MOORE STREET SENIOR APARTMENTS PARKING LOT IMPROVEMENTS
PROJECT NO. ITB-26-15
ADDENDUM NO. 2

July 20, 2026

The following changes, clarifications, and or additions are hereby made to the MOORE STREET SENIOR APARTMENTS PARKING LOT IMPROVEMENTS, PROJECT NO. ITB-26-15

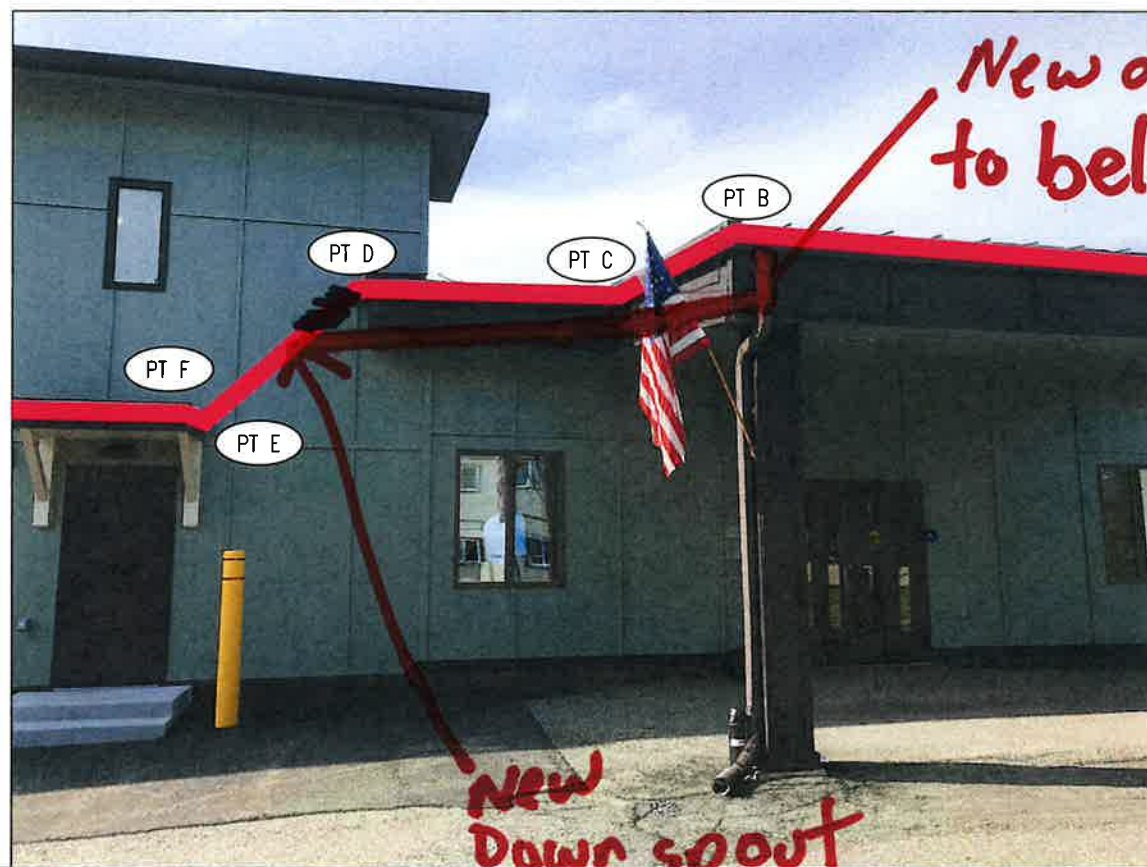
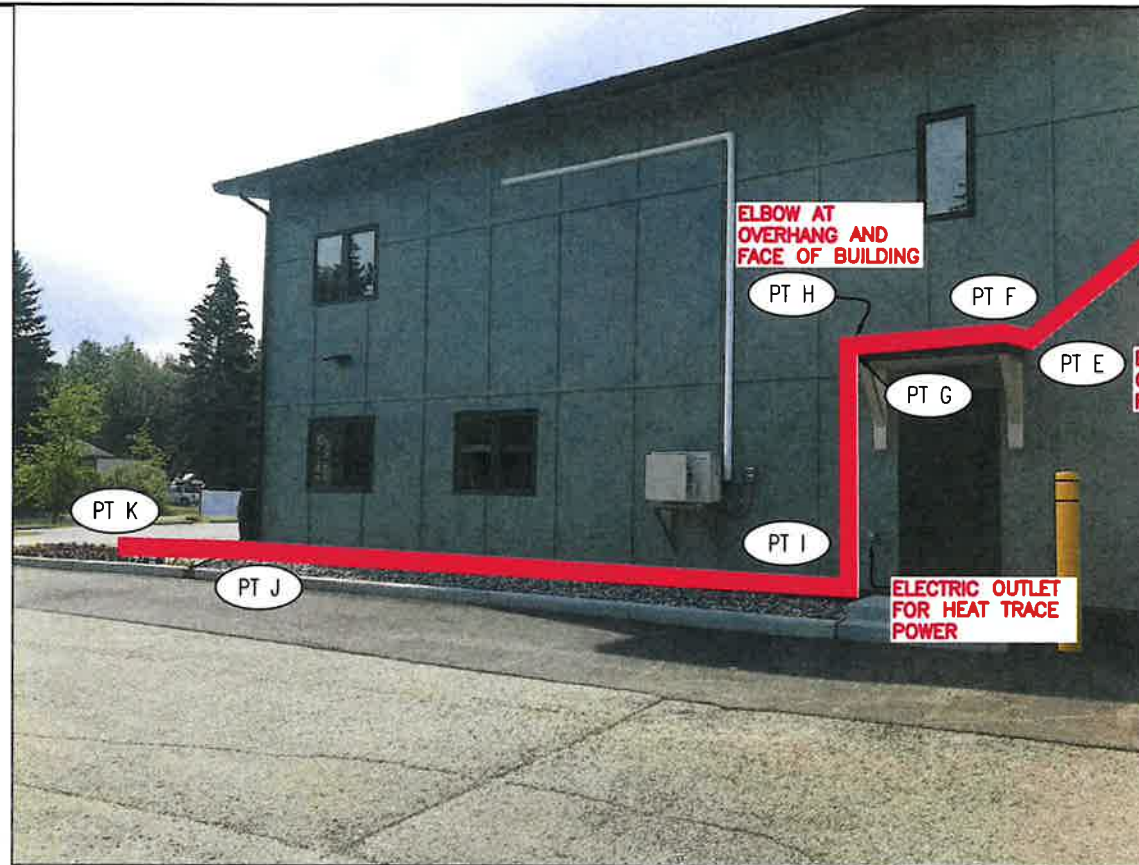
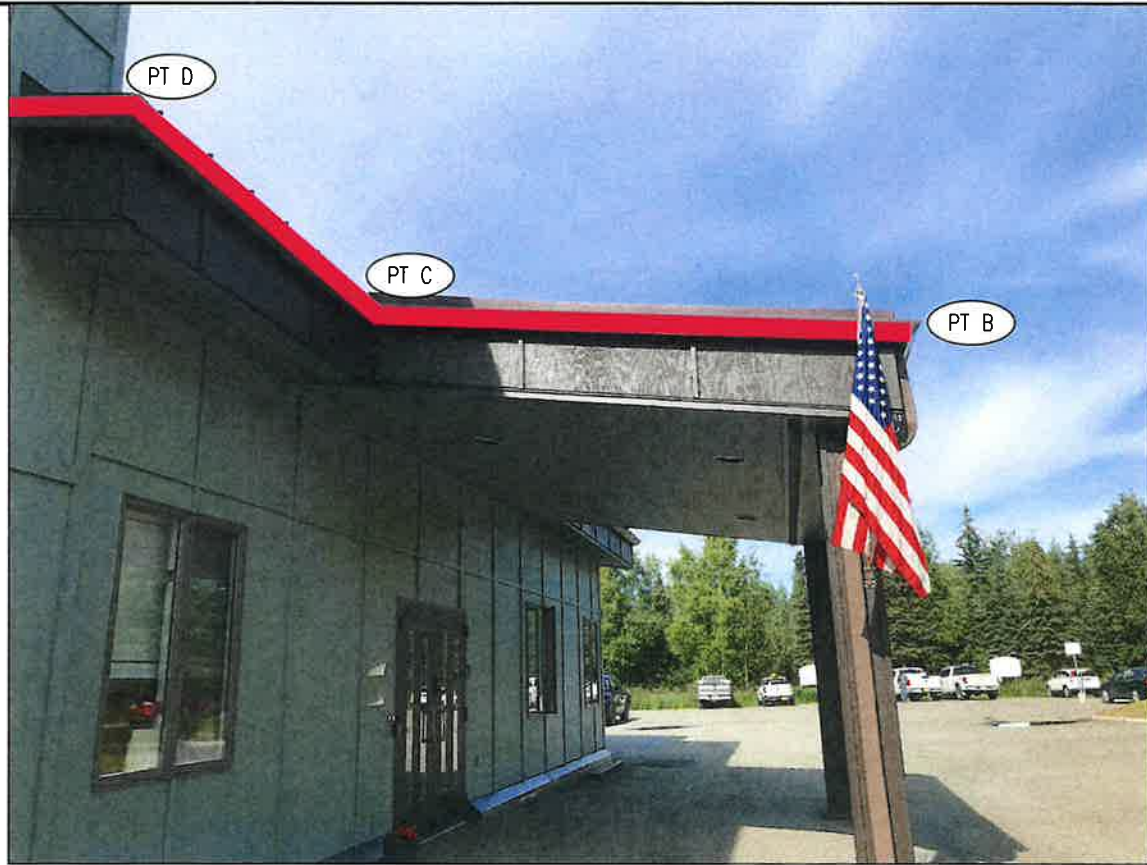
- **Sheet R1 : Modifications to Senior Center Roof Drain.**
- **Pen & Ink Modification – Sheet C1 – Estimate of Quantities – Modify Item 608.2001.0000 Steel Bollard, Fixed to 606.2001.0000 Steel Bollard, Fixed**

- 1. Steel Bollards (Qty 18) – Powder coating not required. Finish shall be (2) coats of Safety Yellow Paint.**
- 2. Roof Drain System Modifications**
 - Existing Roof Gutter from Point A to Point D to remain as is.
 - Start modifications from existing Downspout and install new roof gutter, securely attached to building, to a point between Point D and Point E as shown on Sheet R1 Modifications.
 - Snow guards (snow stops) will not be required as part of this project.
 - Heat Trace is intended to rest freely in the gutter.

Roof Gutter From PT A to PT D to remain.
